Sea Link

Volume 9: Examination Submissions

Document 9.76.2: Change Request Report

Planning Inspectorate Reference: EN20026

Document Ref: A3	Scale: 1:7,500	Format: A3	Sheets: 1	Rev: 0
---------------------	-------------------	---------------	--------------	-----------

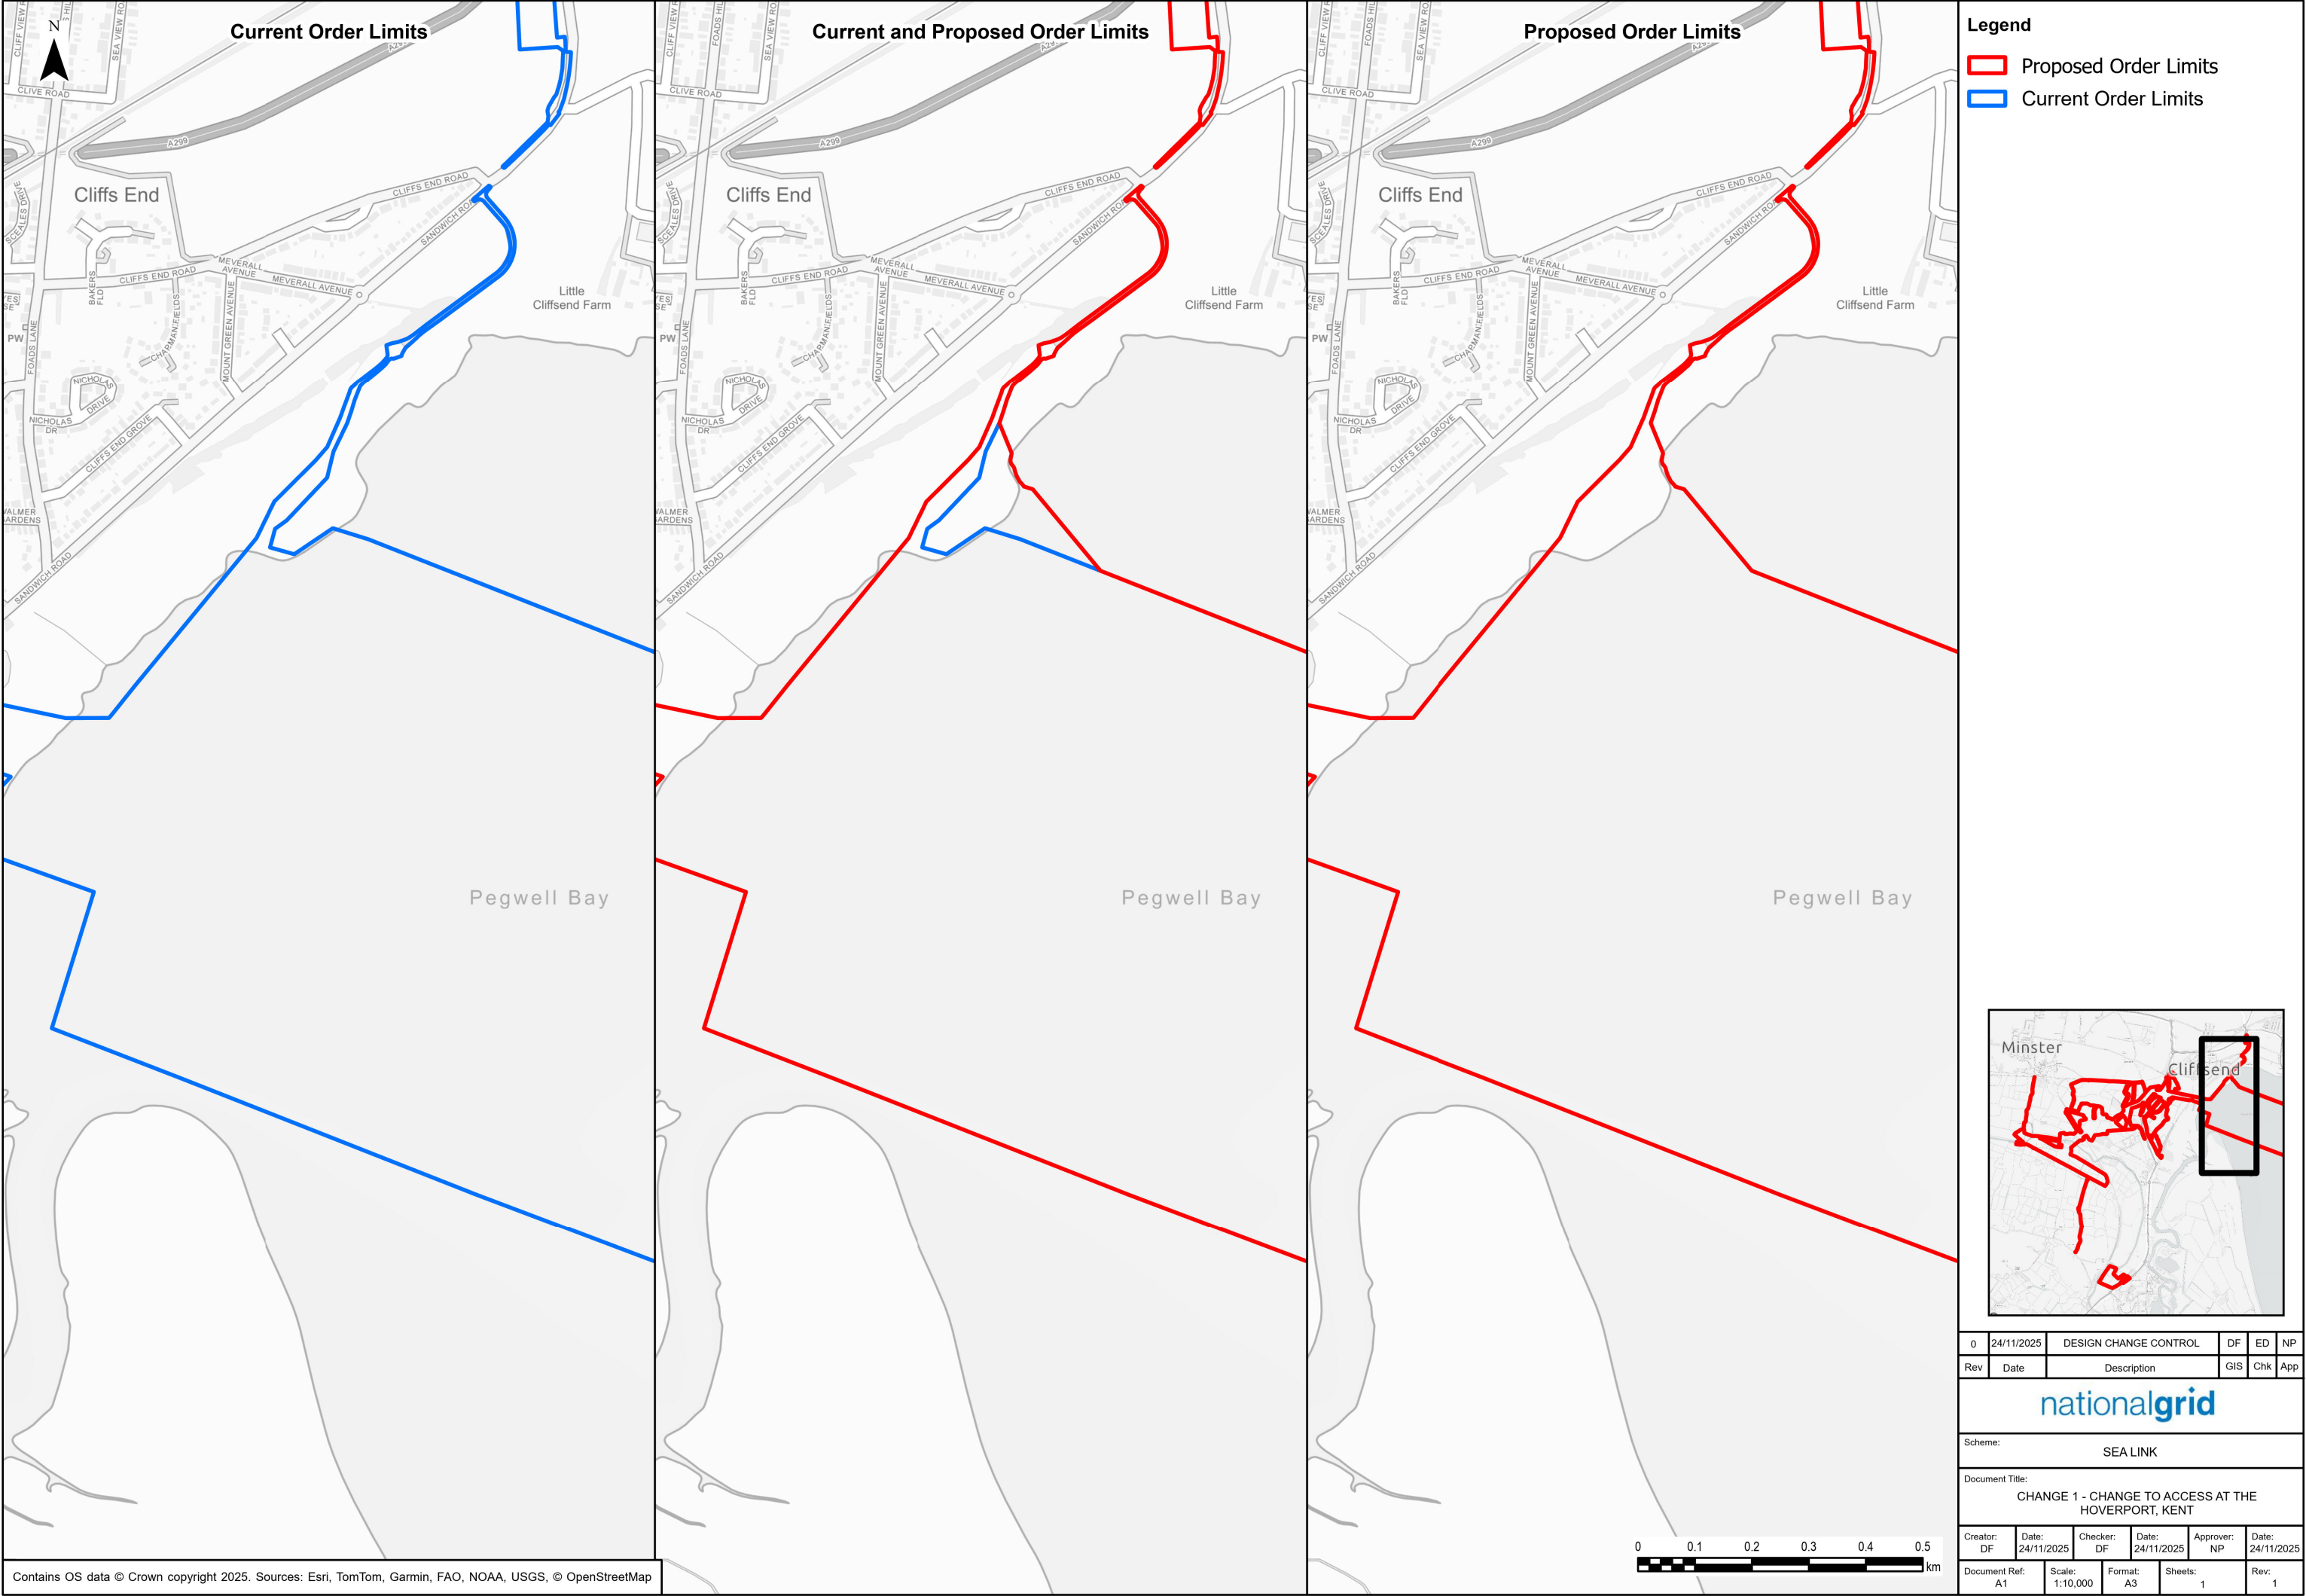
- 2.4.11 As a result of the further survey and subsequent discussions with heritage stakeholders, and to ensure the additional rights sought are necessary and proportional, National Grid has reduced the proposed extension to the Order limits in the area of change 3 for the Change Request. This removes the option of routing the cable and haul road to the west of the feature in response to the geophysical survey results showing potential archaeological features of interest in this area. This approach is supported by Historic England and the County Archaeologist. However, the Change Request retains two options:

- 2.4.12 The Change Request retains both options at present given that further investigation is planned to establish the value of the area to the east of the site and look in more detail

at both options to determine the best outcome. The eastern extent of the amended Order Limits is the same as those proposed in the Notification letter, but the area of the enclosure has been added back in, including the full area of the feature. The western extent of the amended Order Limits as proposed in the Notification Letter **[AS-138]** is removed from the proposed Order Limits in response to the geophysical survey results that potential archaeological features of interest may be present in this area. This approach is supported by Historic England and the County Archaeologist.

Appendix D : Change 4 Benhall Railway Bridge, Suffolk Proposed Change Drawing

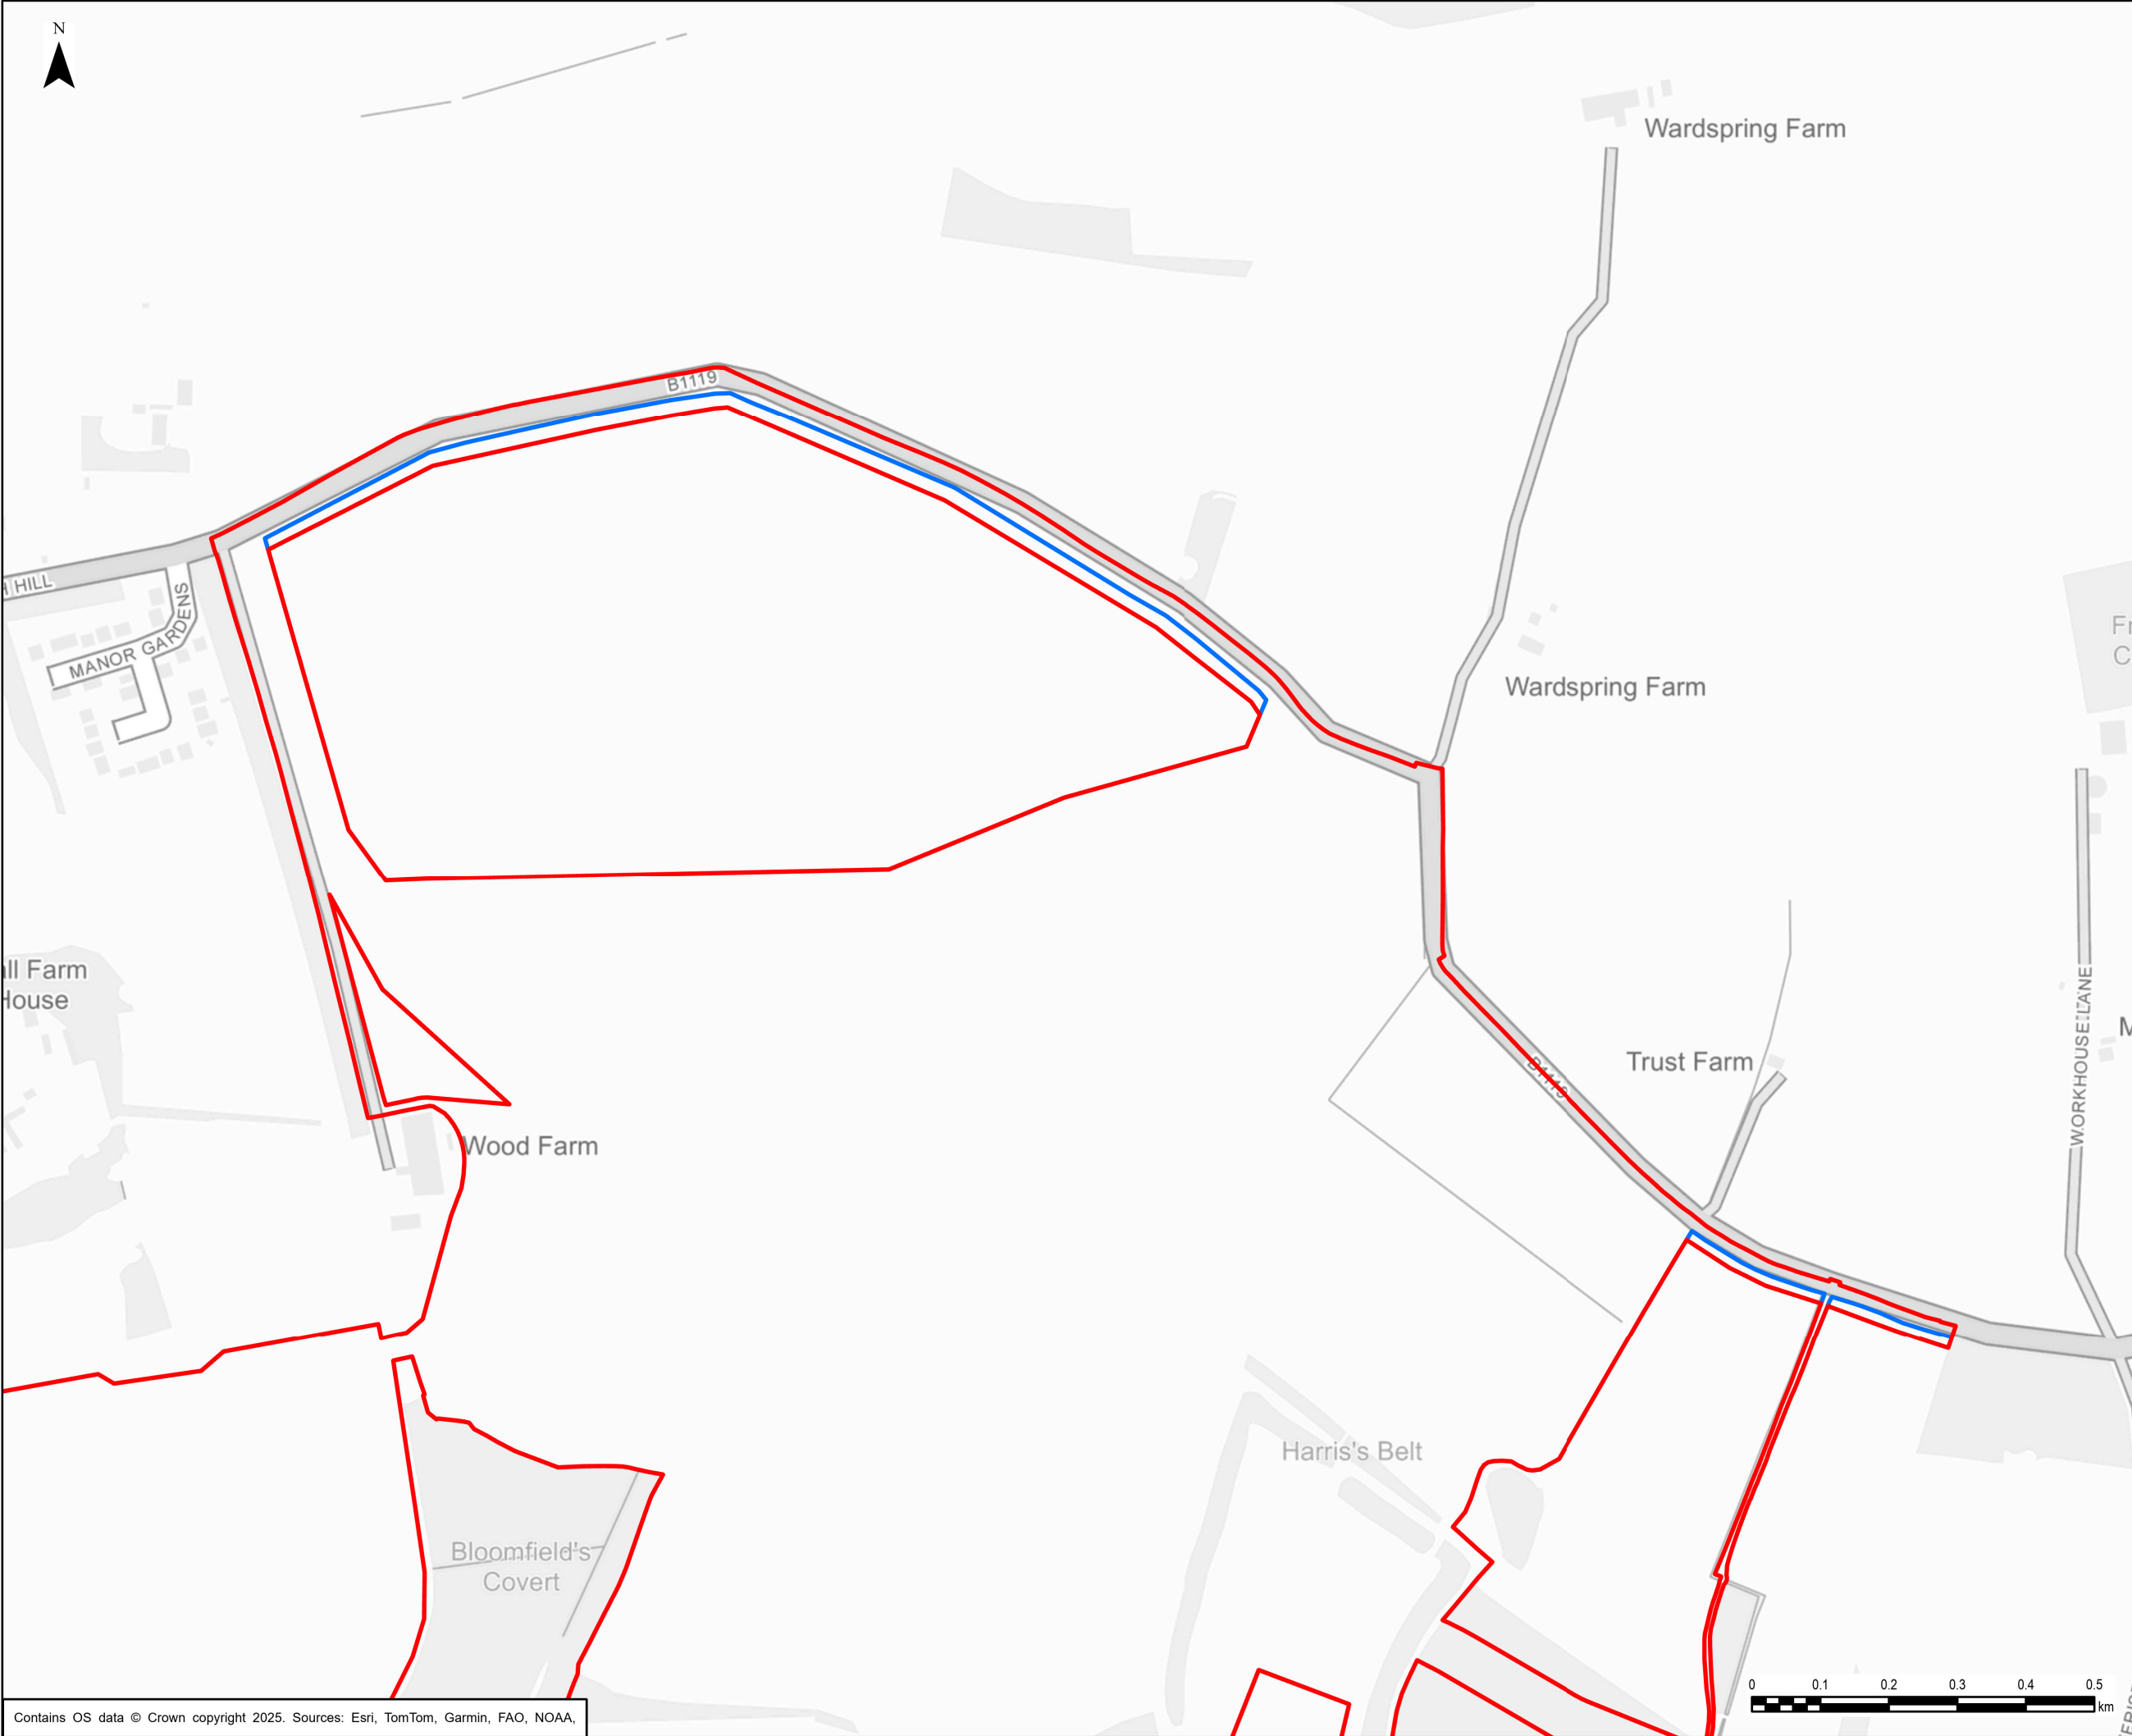
- 2.5.1 In National Grid's Notification Letter **[AS-138]** this change proposed to introduce land into the Order Limits along the B1121, including Benhall Railway Bridge over the railway and associated land along the highway to the east and west of the bridge between the A12 and Grays Lane/ Forge Close. The proposed change also included additional land to the east of the B1121 and a small stretch along the railway line.

Change 4 as Proposed in the Change Request

- 2.5.18 In the period between submission of the Notification and this Change Request, National Grid held discussions with the landowner of the land adjacent to Benhall Railway Bridge (and their agents dealing with the planning application) and East Suffolk to better understand the position with the housing application. These discussions indicated that whilst the application had not progressed for a long time, it was now progressing. On 28 October 2025, after issue of the Notification Letter, the application (application reference DC/21/2503/OUT) for up to 41 residential dwellings was recommended for approval and unanimously approved by the East Suffolk District Council Planning Committee. The landowner also confirmed that the intention was for the site to progress in early 2026 and that use of this area for a compound would potentially delay progression of an allocated housing site; the landowner would therefore object to use of this area for a compound.

- 2.5.22 The Change Request will still enable Options 1 and 2 to be implemented by National Grid:
1. Installation of the 'mini-bridge' within the highway boundary only;

2. Minor works to repair the bridge.
- 2.5.23 A Change Request: Addendum to Volume 6 Environmental Statement as shown in **Application Document 9.76.5** submitted with the Change Request has been prepared and it concludes that the proposed change is not likely to result in any new or different likely significant environmental effects to those documents in the Environmental Statement. In response to the ExA's Rule 9 letter **[PD-011]** National Grid has considered any effects on the highway network for the two proposed options in more detail. An assessment of the traffic impacts associated with both Options is included in the Change Request: Addendum to Volume 6 Environmental Statement **Application Document 9.76.5**. The Addendum concludes that there will be no likely significant environmental effects associated with either the installation of a mini-bridge or minor bridge repairs; both of which would be activities normally delivered using permitted development rights. It should be noted that details of traffic management and length of road closures are not generally known at the application stage and the impact of these closures has therefore been considered in more detail than is typical for a DCO application. However, this detail has been provided given the interest from local communities and key stakeholders on the AIL solution for Benhall Bridge.
